VLBA Electronics Memo No. 73

SUBJECT: Improvement of VLBA/Voyager FET Bias Card

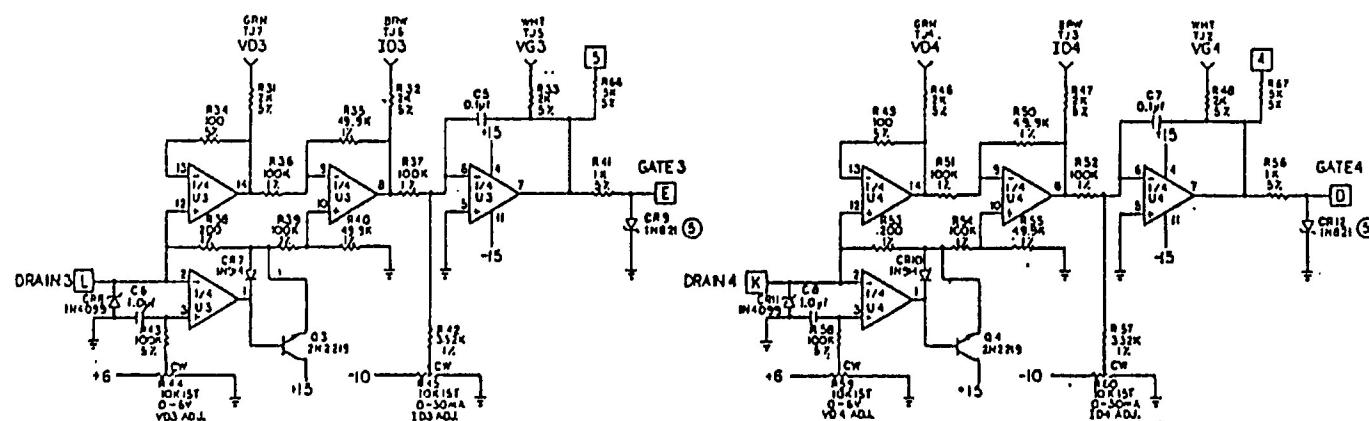
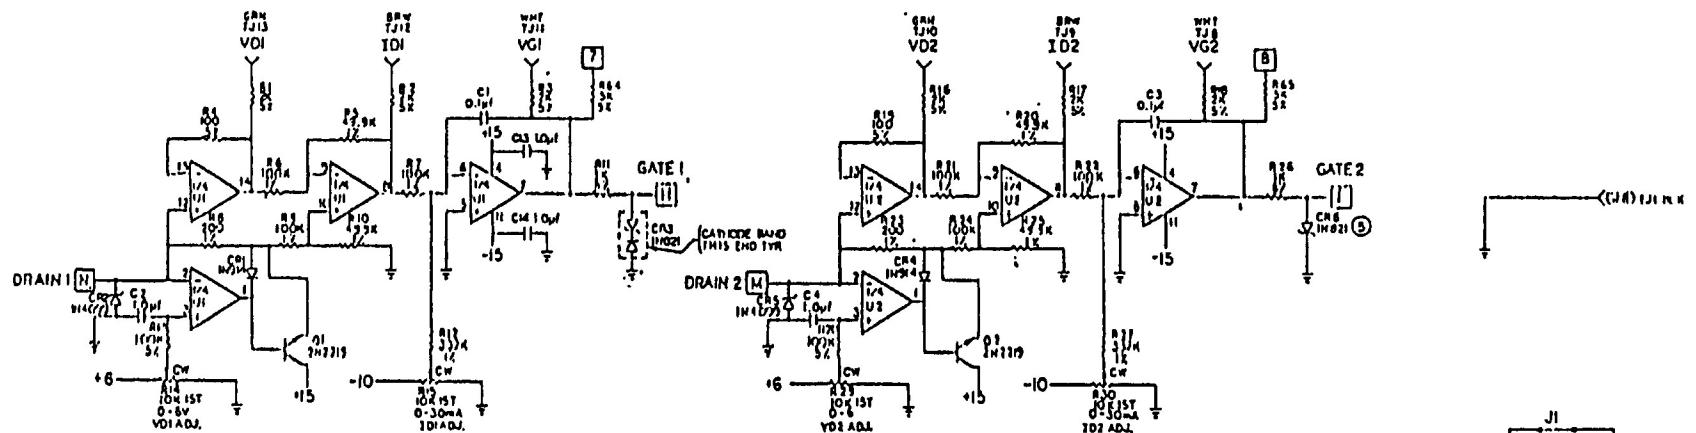
CHANGE TO 470-2, 1/4W, 570

It has been found that the -10 volt regulator (AD581) has insufficient current for proper regulation. This should be corrected by changing R61 from 1.2K to 470 ohm, 1/4 watt, 5% (see attached schematic and layout). The change may increase FET bias currents by 5% and increase front-end gain by a small amount (0.3 dB measured on one 8.4 GHz front-end). The FET bias current pots can either be left alone or reset to the previous drain current.

Y	FRONT END	NATIONAL RADIO ASTRONOMY OBSERVATORY
B	ASSY - BIAS CARD	SEARCHED INDEXED SERIALIZED FILED
		DATE 02-22-90 BY C-A 14-71

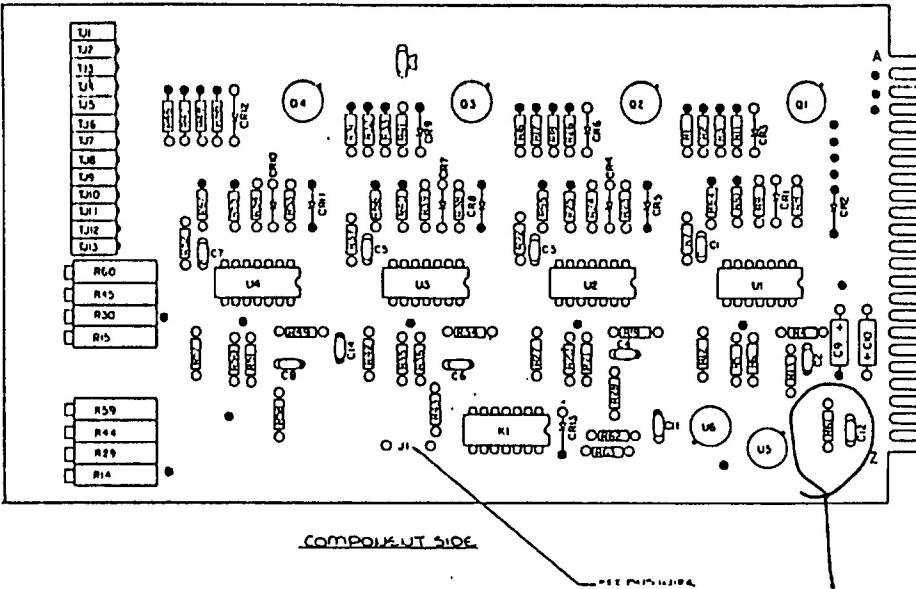
CHANGE
TO
470 SW
1/4W
570
